**City of Lino Lakes
Environmental Board Meeting**

REQUEST: Preliminary Plat and Site Plan Review
Watermark

Re: *Watermark
Plan Review
WSB Project No. 2029-820*

Mattamy Homes Soils-Hydrlic Rating

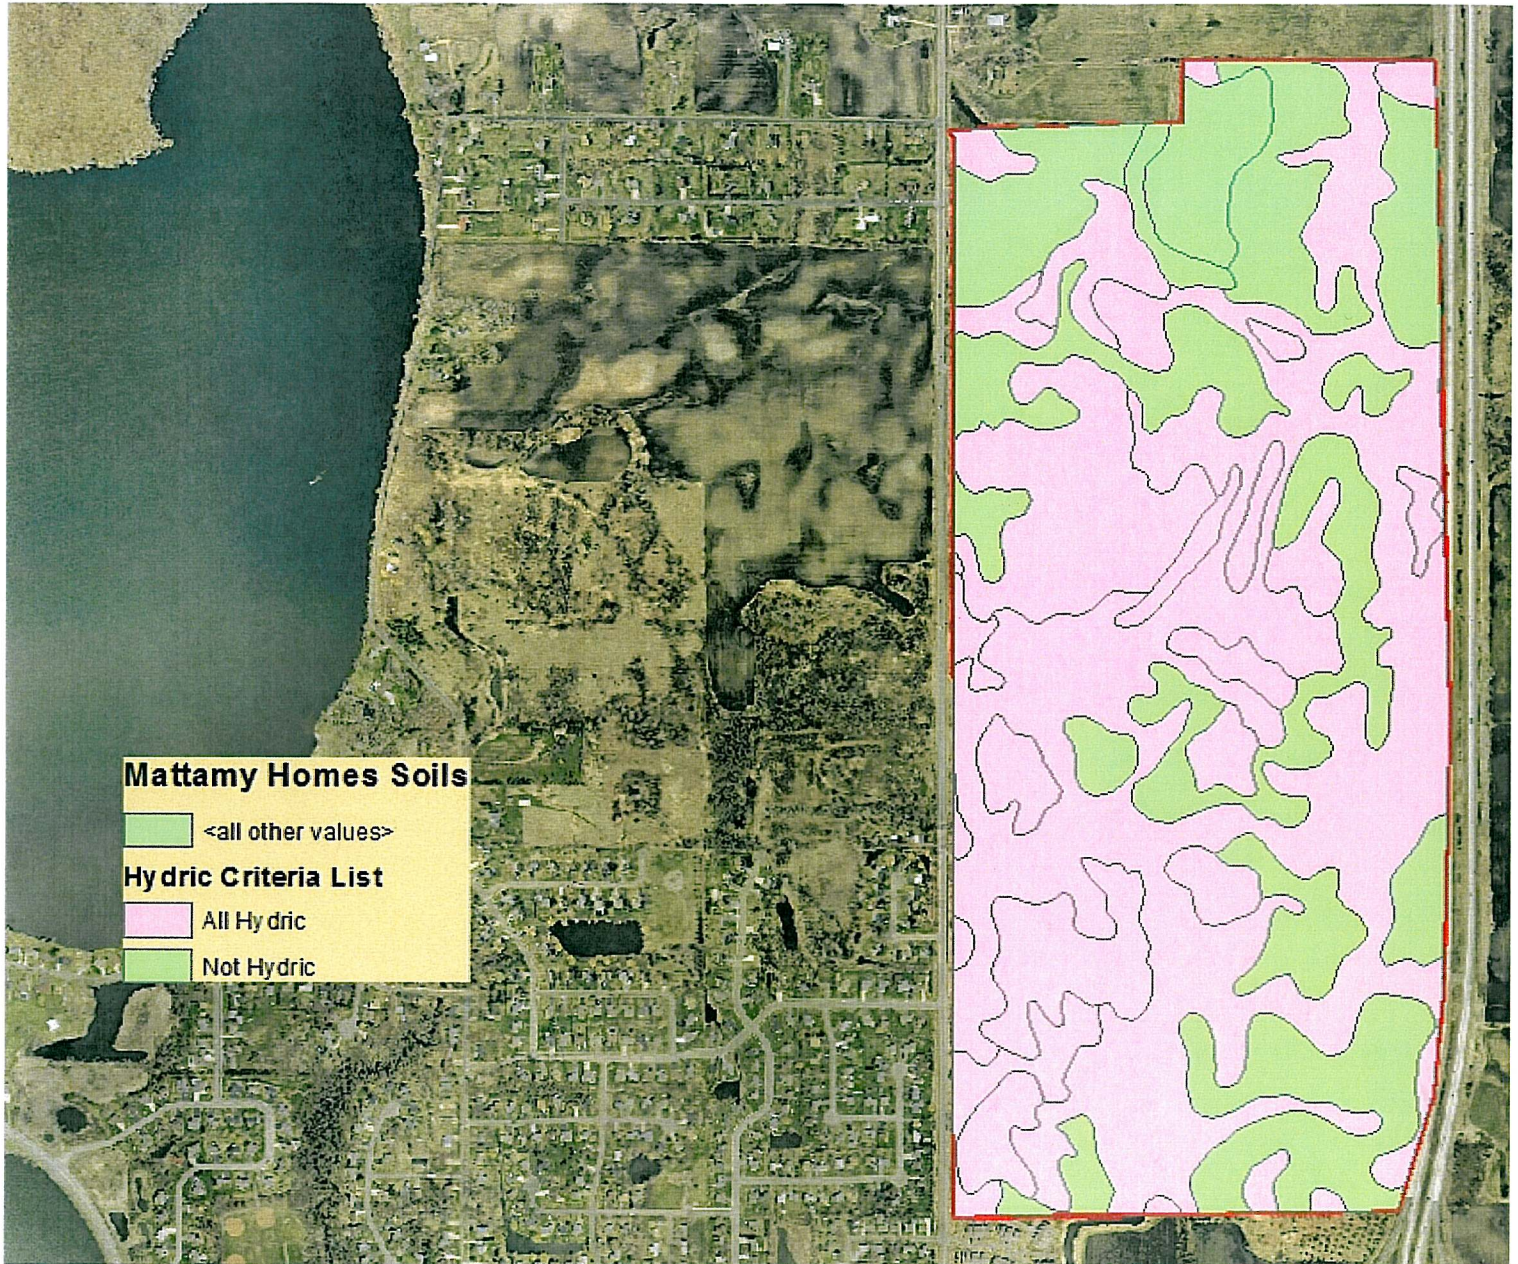
Soils management in the Watermark proposal site is most important consideration from a water management and plant growth perspective. The soils in the Watermark proposal site are very thick glacial deposits of unconsolidated glacial till. These soils are clay with everything else including rocks, boulders and gravel areas. The soils are classified as B/D soils that signifies the soils are drained, and have little infiltration (see attachment). Project soil borings show a fairly consistent subsoil consisting of sandy clay with some occasional traces of gravel down to 16 feet. Water elevations in some the test borings

Typical Berm Plan and Section

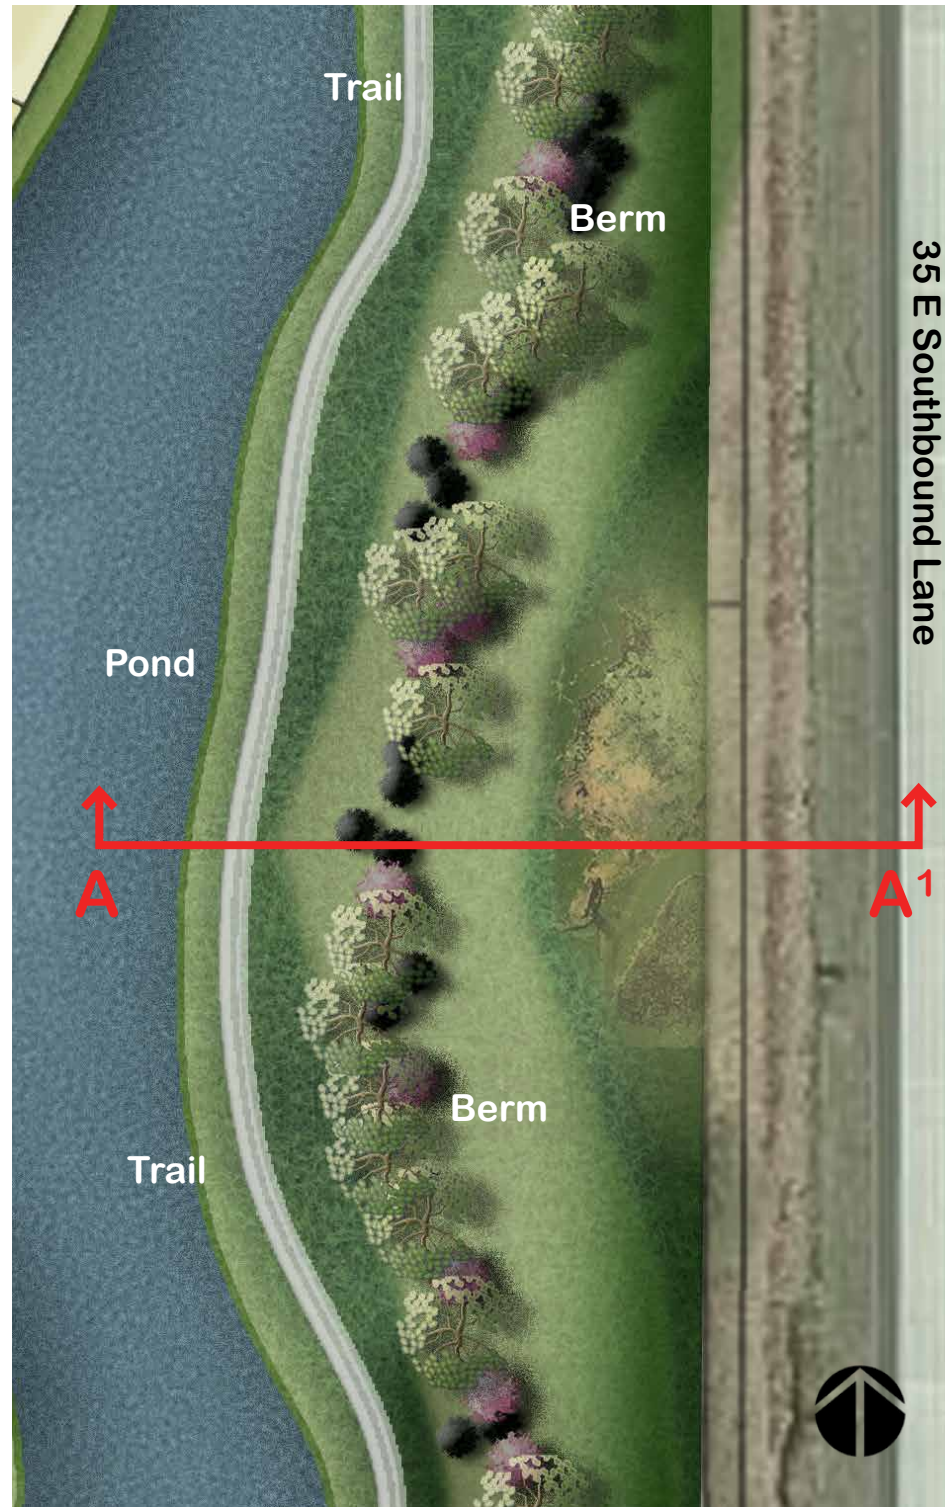
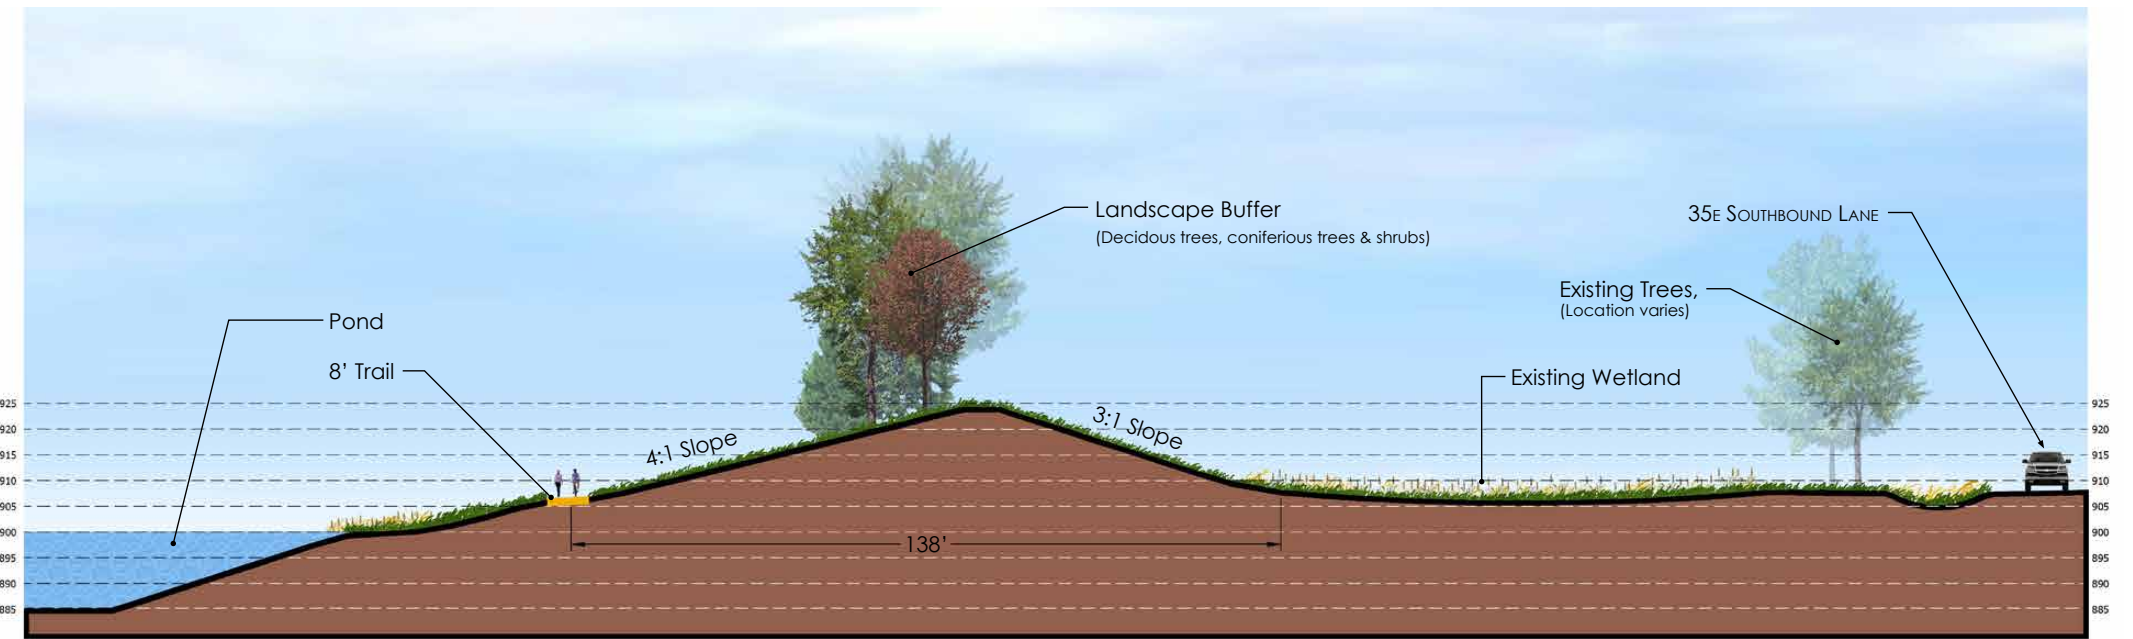
Landscape berms will be constructed along both I 35E and CSAH 54. The berms along I 35E are approximately 150 feet in width and 25 feet high. A mix of deciduous and coniferous trees and shrubs will be planted near the crown.
